Approval of Reserved Matters Consultation

Application Number: 250399

Site Address: Parcel R10 South Wokingham, Phase 2b, Parcel R10

MEMORANDUM

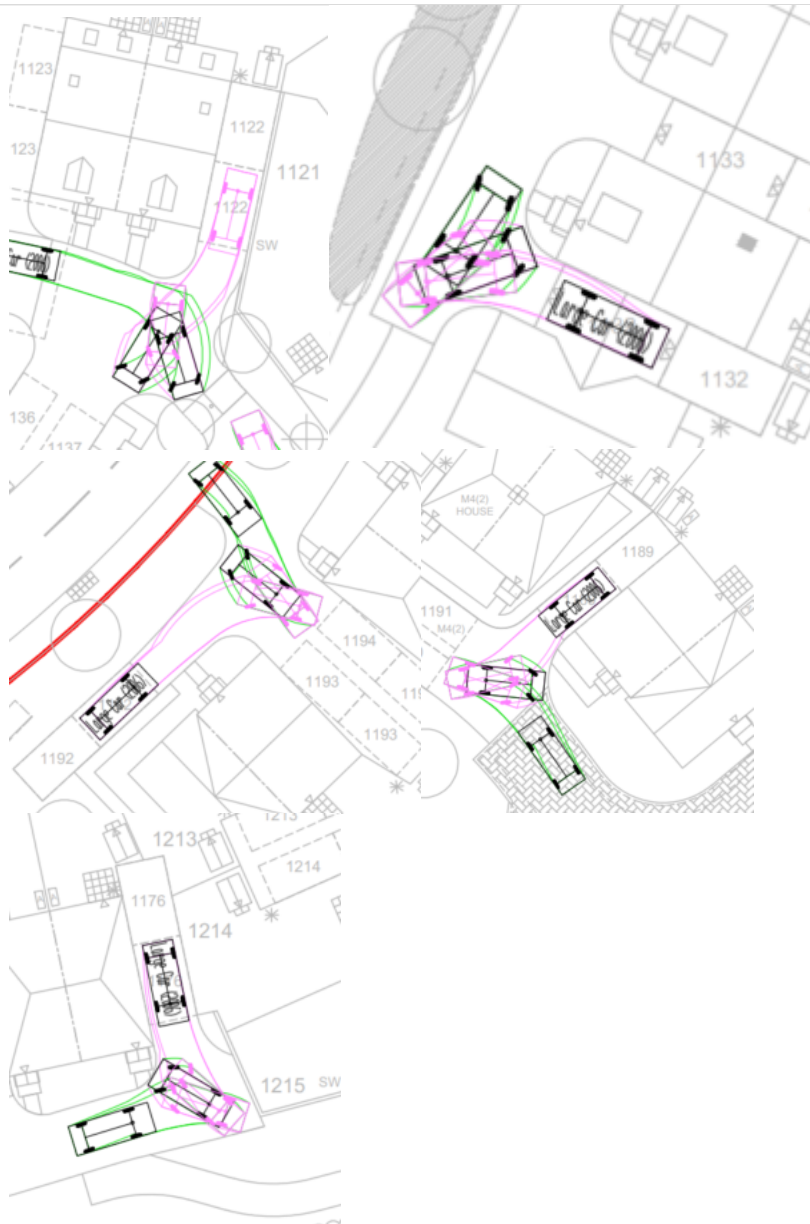
48. Highways is also concerned with the manoeuvring of parked cars in the parking court for blocks 5 and 6 as shown below and will need reviewing.

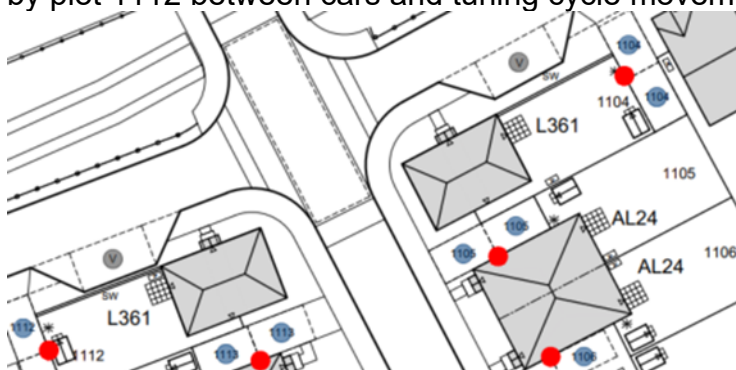
50. Highways is also concerned with the manoeuvring of a car into the end space of block 7 as shown below which will need to be reviewed. Highways would also like swept paths analysis carried out for the opposite end space.

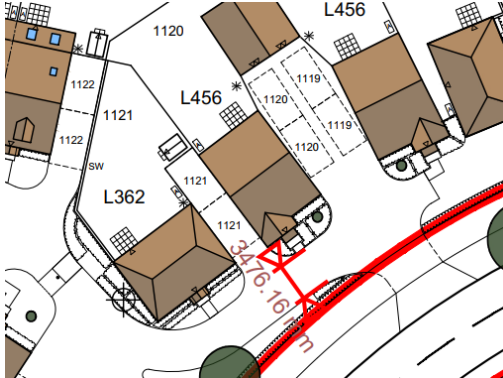
72. A proposed adoption plan (Drawing A389-R10-RM-103 Rev A) has been submitted which is welcome. Highways would recommend that the access roads to the rear of Blocks 1 to 4 are excluded from the adoption plan and the demarcation is moved closer to the spine road.

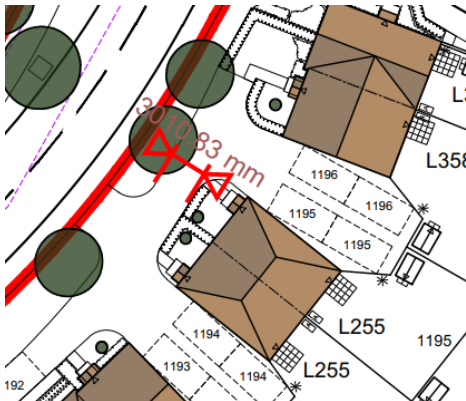
80. The width of the private road outside plot 1120 needs to be 4.1m not 3.5m as shown below.

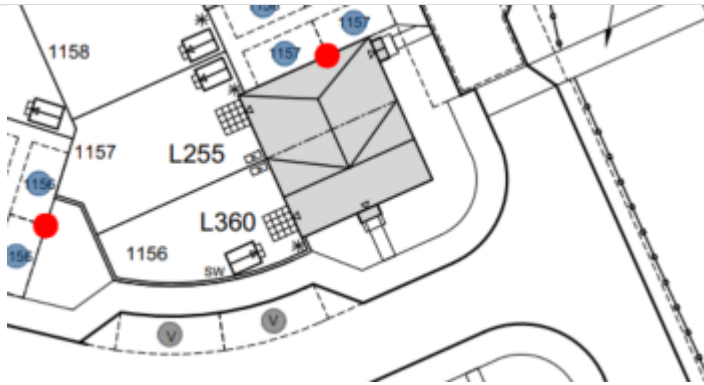
81. The width of the private road outside plot 1195 needs to be 4.1m and not 3m as shown below
